# 1200 Pike

**Design Review Board Meeting**  
**1200 E Pike Street | SEATTLE, WASHINGTON 98122**

TARRAGON | 1200 PIKE LLC | ANKROM MOISAN ARCHITECTS, INC.  
AUGUST 14, 2013

## 4. Materials

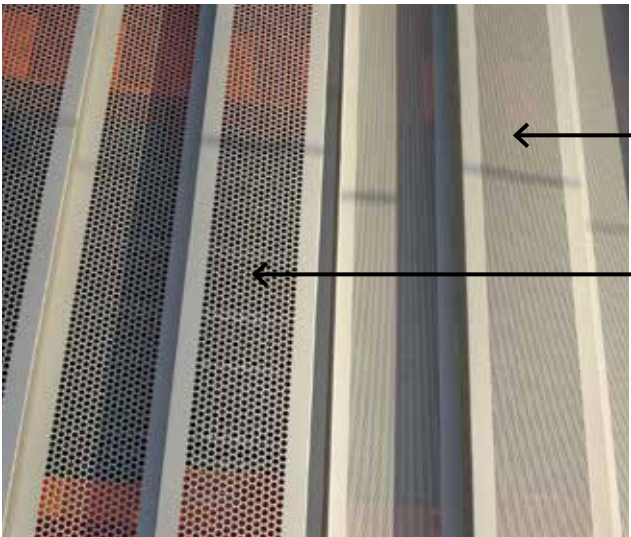
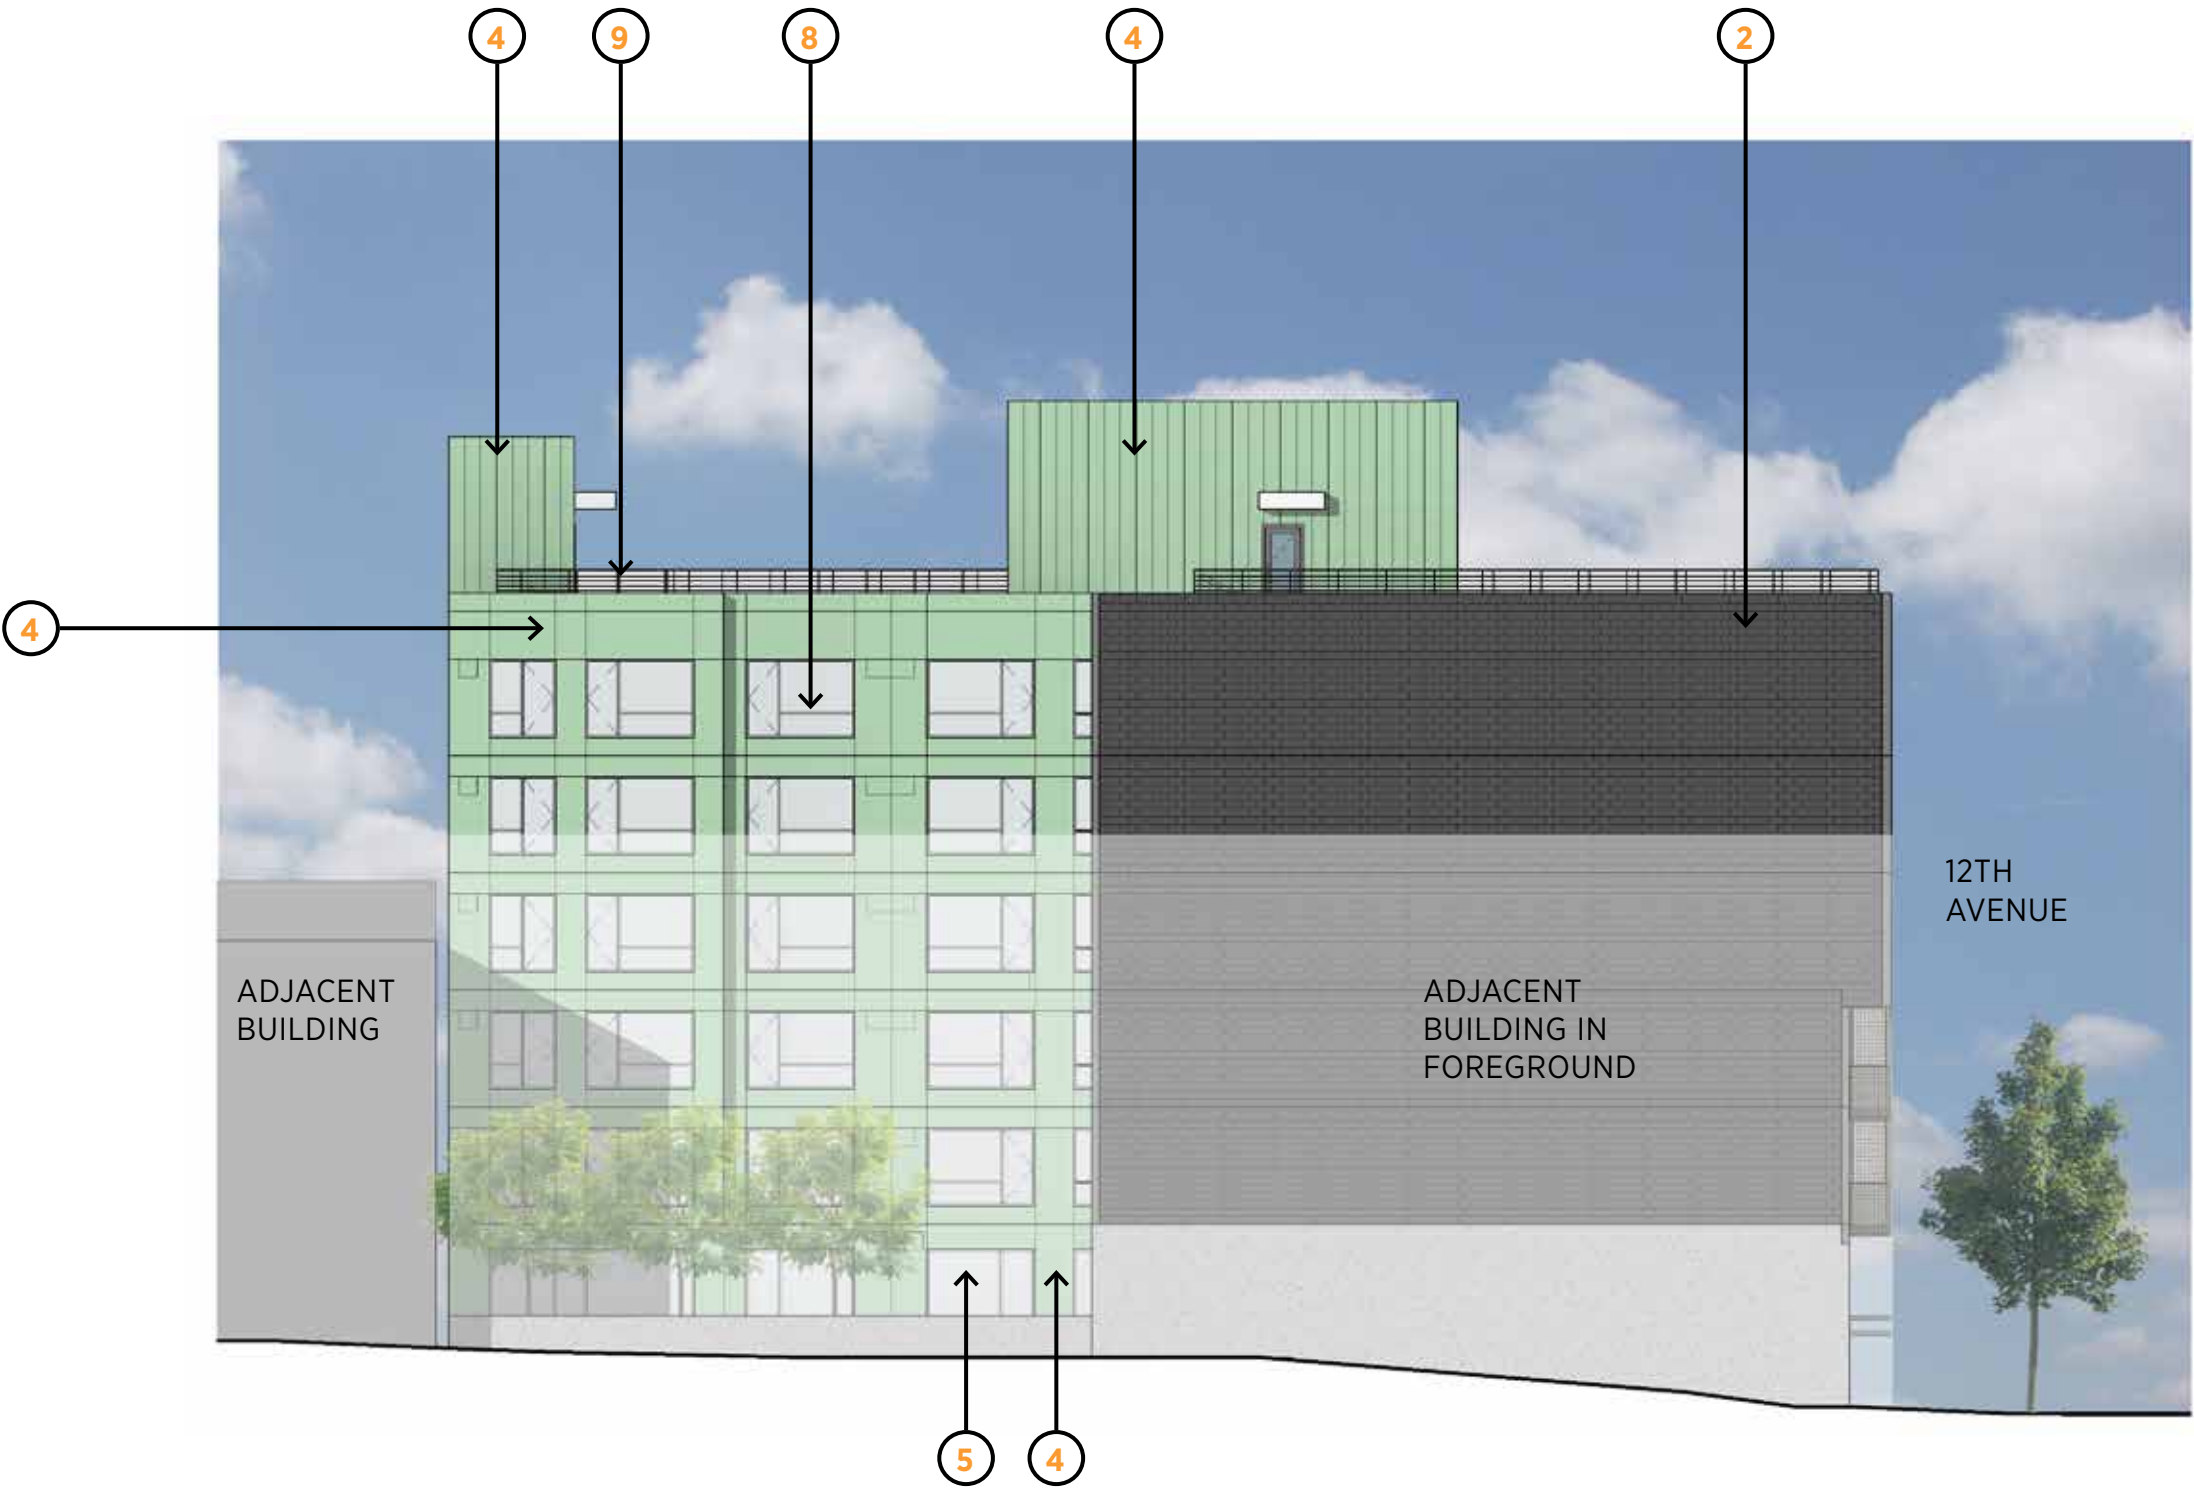
- “The visibility of the site, the context, and the concept indicate that high quality durable materials should be used, especially in the street facing facades. The Board noted that cement board wouldn’t be appropriate for these facades.”
- “The Board noted that the conceptual sketches indicated one type of treatment for the first 2 stories of the building and another type of treatment for the upper 3 floors. The materials should instead be used to express the building construction type, with one level of commercial and residential uses above.”
- “The fin walls should be designed with high quality materials that provide human scale and visual interest.”

- 1 METAL PLATE PANEL
- 2 GROUND FACED CMU
- 3 PERFORATED SCREENS
- 4 FIBER CEMENT PANEL
- 5 FIBERGLASS WINDOW SYSTEM
- 6 WOOD SOFFIT | SIDING
- 7 LOUVERS
- 8 VINYL WINDOW
- 9 CABLE RAILING

1. SITE TRIANGLE

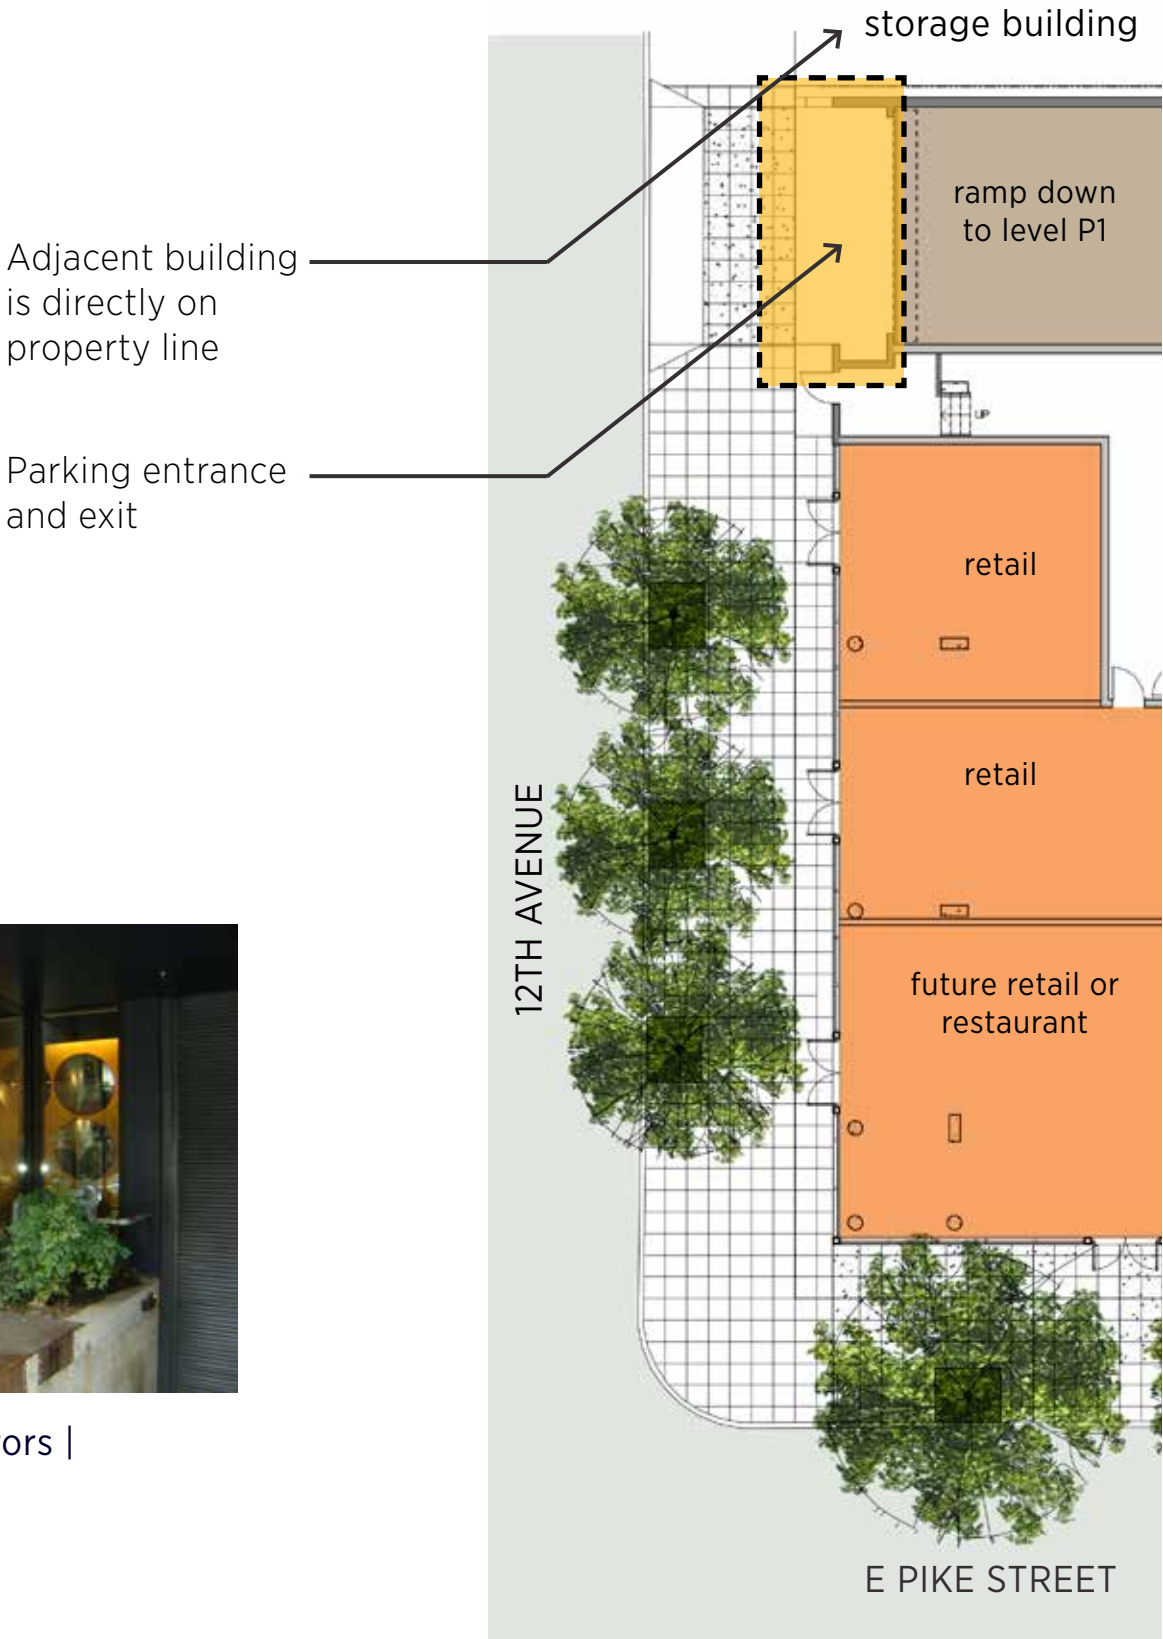
For exit-only driveways and easements, and two way drive-ways and easements less than 22’ wide, a sight triangle on both sides of the driveway or easement shall be provided, and shall be kept clear of any obstruction for a distance of 10’ from the intersection of the driveway or easement with a driveway, easement, sidewalk or curb intersection if there is no sidewalk.

For two-way driveways or easements 22’ wide or more, a sight triangle on the side of the driveway used as an exit shall be provided, and shall be kept clear of any obstruction for a distance of 10’ from the intersection of the driveway or easement with a driveway, easement, sidewalk, or curb intersection if there is no sidewalk. (SMC 23.54.030)

We propose to utilize mirrors in lieu of providing a site triangle. Only 38 cars will be exiting the garage and we are painting the entry area an accent color to denote the change in use. The sidewalk paving pattern will also change in this location and signage/lighting will be provided.

In keeping with Design Guideline A-8, the parking access opening is minimized in width by opting for the use of mirrors and as noted below.

Our goal is for the driveway to be located as far from the corner as possible to allow for as much unbroken, retail store frontage along 12th Avenue and E Pike Street. Locating the driveway any closer to the corner would break up the retail pattern we are trying to achieve and would not respond as well to the design guidelines. This will also prevent cars from entering/exiting near a very busy intersection.

Our project abuts adjacent buildings on each property line and accounting for a site triangle would require moving the driveway toward the corner 10+ feet to avoid the adjacent building, affecting the retail pattern as mentioned above. The ramp is set back 6+ feet to help delineate the parking entrance.

Due to the slope of the site and the size and scale of our project, below grade parking is very challenging. Locating the driveway in its current location provides the best efficiency for the project and is in the least intrusive location. There are also precedents within the neighborhood for similar conditions.

2. RESIDENTIAL ENTRY

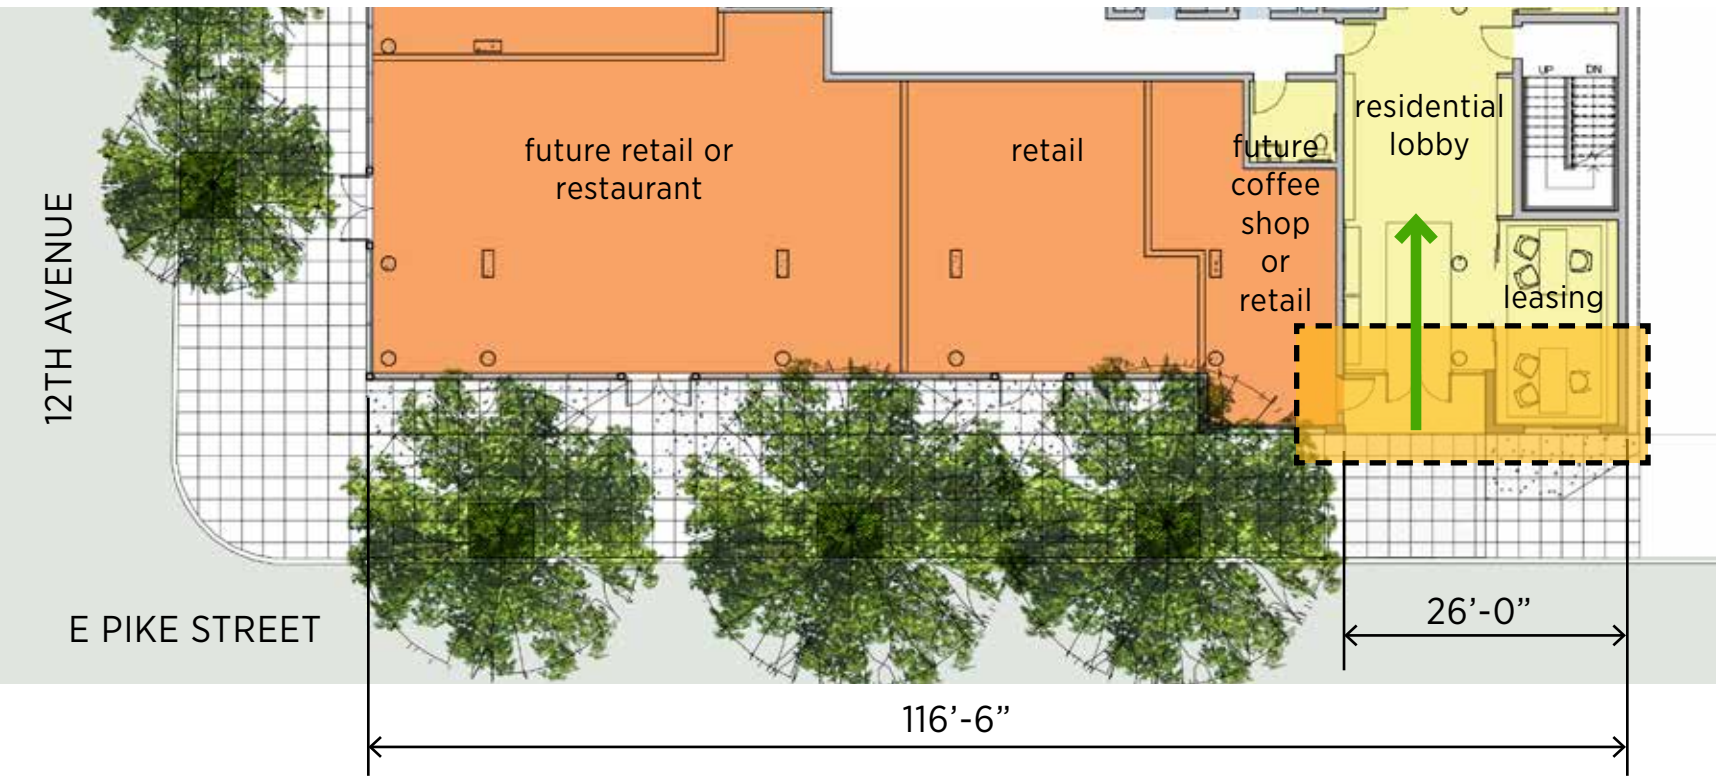
*In all neighborhood commercial and C1 zones, residential uses may occupy, in the aggregate, no more than 20% of the street-level street-facing facade in the following circumstances or locations: in a pedestrian-designated zone, facing a designated principal pedestrian street. (SMC 23.47A.005)*

Our proposed residential entry is located on E Pike Street. The width of the building along E Pike Street is approximately 116'-6", which would allow for 23'-0" of residential use at 20%. Our current residential entry is 26'-0" in width, which is approximately 22%.

The proposed massing is anchored to the ground at the residential entry and increasing the residential use by 2% helps to strengthen the massing and create a more significant entry. There will be a high level of transparency at the ground level in this location with floor to ceiling glazing at the main entry and large window openings that mimic the fenestration above. The 2% increase will also allow for the leasing office to be located adjacent to the main entry doors, which provides the required security and site lines for those entering the building.

In keeping with Design Guideline D-12, the increased width provides for a visually interesting street front that enhances the character of the streetscape and provides a gracious transition.

- 116'-6" X 20% = 23'-0" = Allowed Residential use
- 116'-0" X 22% = 26'-0" = **Proposed Residential Use**

3. PARKING ENTRY

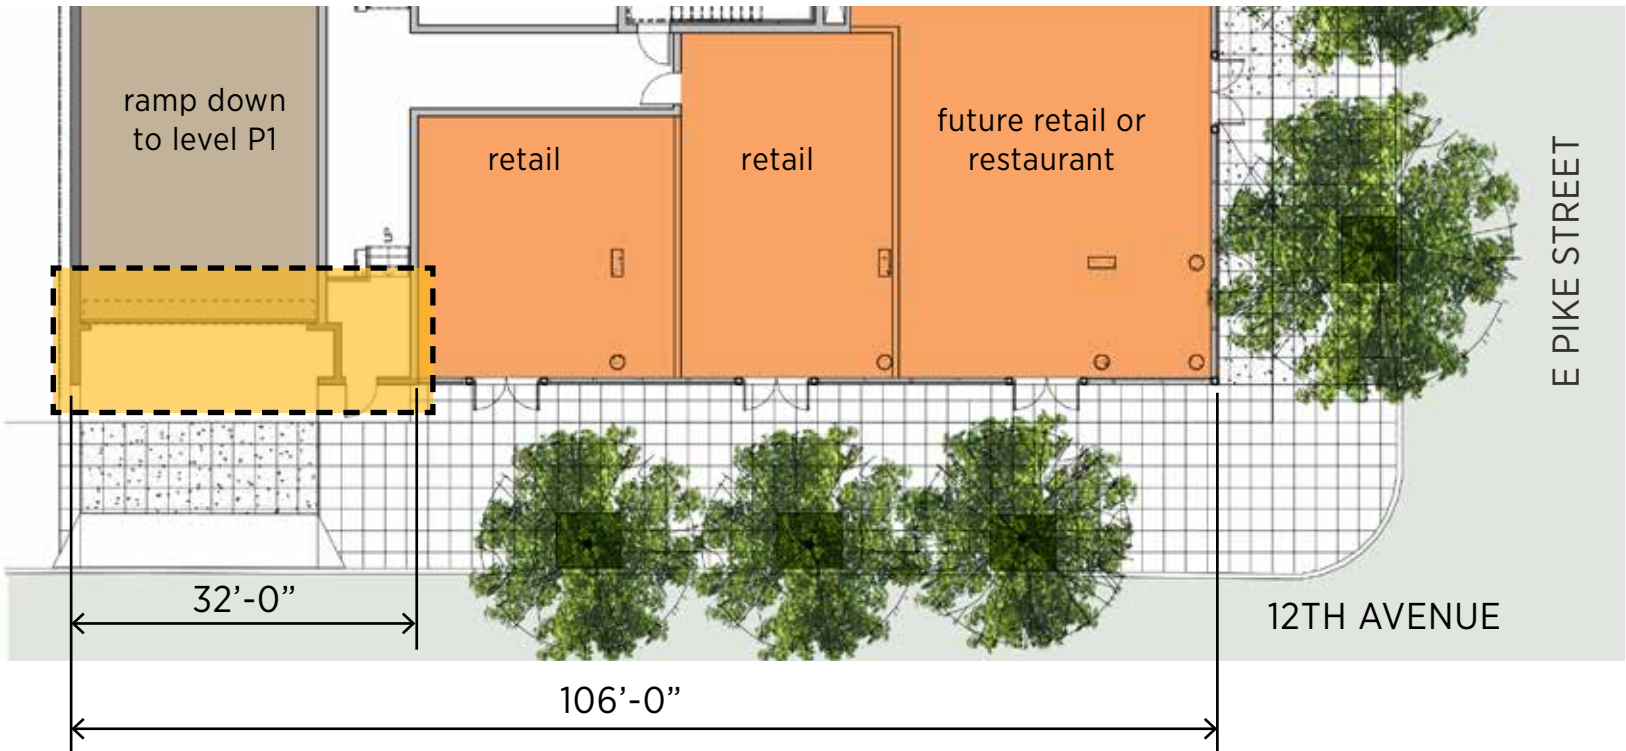
*In all neighborhood commercial and C1 zones, residential uses may occupy, in the aggregate, no more than 20% of the street-level street-facing facade in the following circumstances or locations: in a pedestrian-designated zone, facing a designated principal pedestrian street. (SMC 23.47A.005)*

Our proposed parking entry is located on 12th Avenue. The width of the building along E Pike Street is approximately 106'-0", which would allow for 21'-2" of residential use at 20%. Our current parking entry and required egress are 32'-0" in width, which is approximately 30%.

There are only 38 parking stalls below grade, which are designated for resident use and future resident parking. Therefore the parking entry is considered residential use. There is no alley access for this site and in order to meet the required driveway size requirements, the parking entry cannot be reduced in width any further.

As noted in the site triangle departure, we feel the current parking entry location is the most appropriate location for this site. We have also re-located the retail trash to the parking level, which helped to reduce the blank wall along 12th Avenue and have provided as much retail frontage as possible.

In keeping with Design Guideline A-8, by opting for other safety devices, the width of the site triangle is avoided and the parking entry's impact on the facade is minimized.

- 106'-0" X 20% = 21'-2" = Allowed Residential use
- 106'-0" X 30% = 32'-0" = Proposed Residential Use
